# ORIGINATION FORM

Proposed Revisions to a Standard Plans Index  
(Please provide all information – Incomplete forms will be returned)

Index Number: 443-001  
Sheet Number (s): 1 of 1  
Index Title: French Drain

Update and Reorganized Index. Removing language and moving it to the appropriate document (Specs, SPI...).

**LONGITUDINAL SECTION**

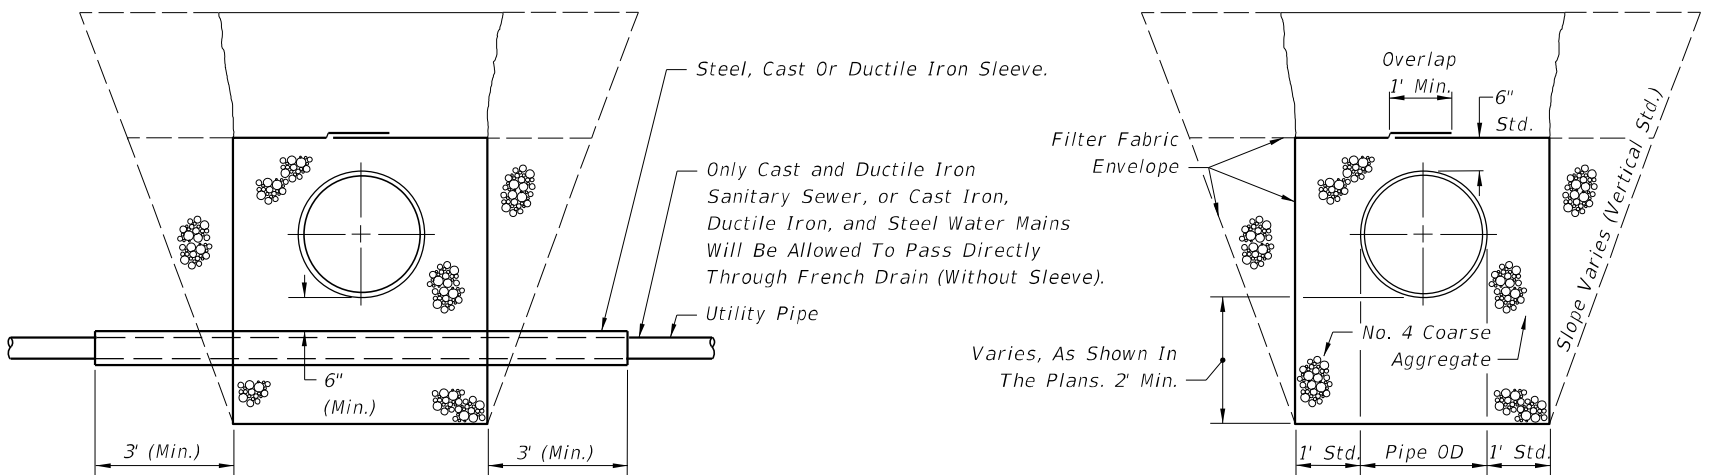
NEW SHEET 1 OF 3

"GENERAL NOTES - TABLE OF CONTENTS - FRENCH DRAIN ASSEMBLY

Sumps Are To Be Constructed Unless Excluded In The Plans.  
Weep Hole To Be Constructed Only Where Called For In The Plans.  
For Additional Sump Bottom Information See Index 425-001.

**FRENCH DRAIN SYSTEM**

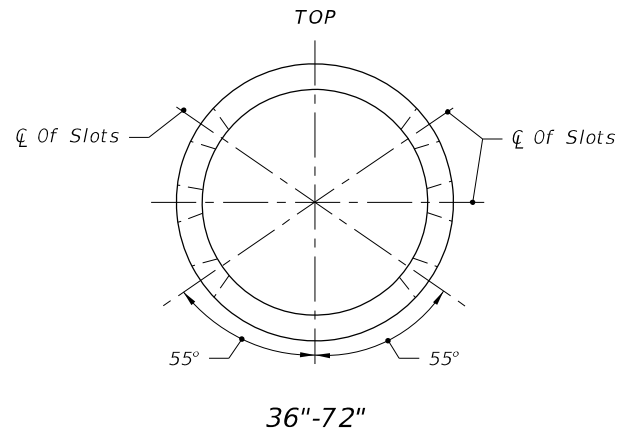
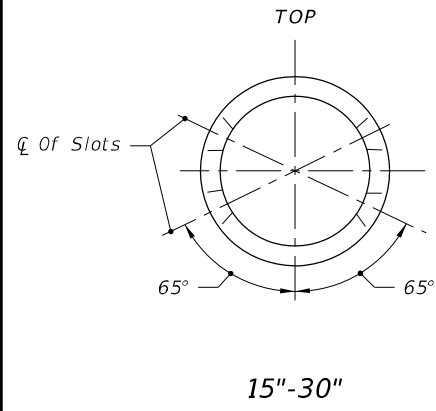
**SHEET 2 - UPDATED**

**MOVED TO SHEET 1 - UPDATED**

**MOVED TO SPI OR SPECIFICATIONS**

SLOTTED PIPE OPTIONS

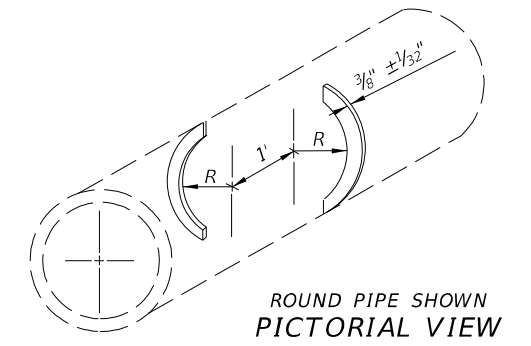
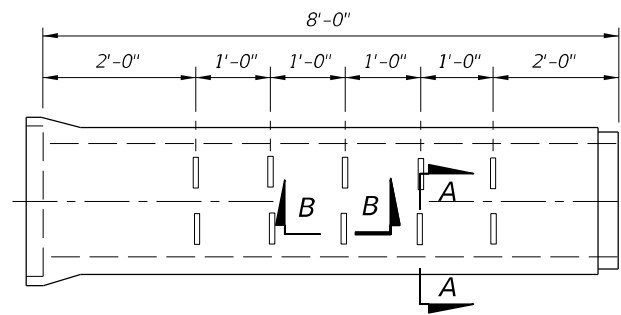
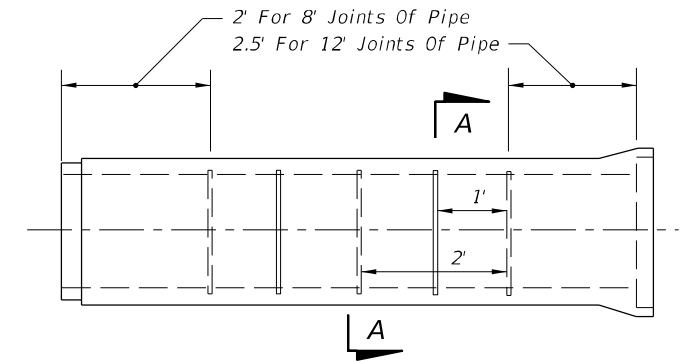
UPDATED SHEET
